Amendments to the Drawings:

Appln. No.: 10/615,254
Applicant(s): Mazzola Jr. et al.
COFFEE BREWER

ANNOTATED MARKED-UP DRAWING
1/6

FIG. 1

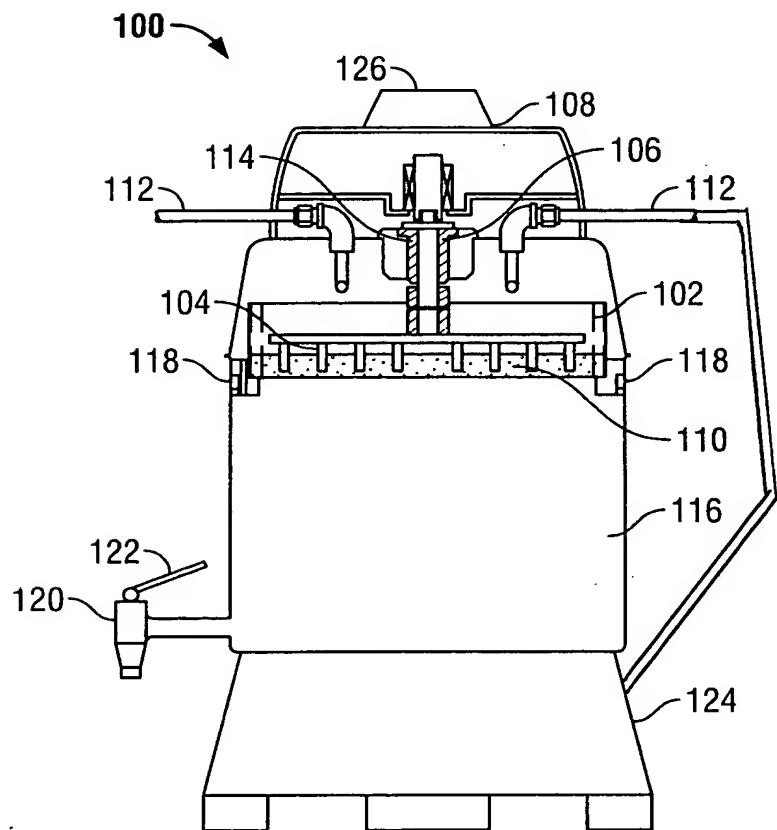
The attached replacement sheet of drawings includes changes to Fig. 1 and replaces the original sheet.

The drawings were objected to because the subject matter of claim 11 was allegedly not shown. Attached is an “annotated marked-up drawing” of Fig. 1 showing the change being made to Fig. 1 to overcome the objection. A “replacement sheet” for Fig. 1 is also enclosed. This objection has been overcome.

The paragraph beginning at page 6, line 4 of the specification has been amended to delete “(not shown)” in line 6 because of the amendment to Fig. 1.
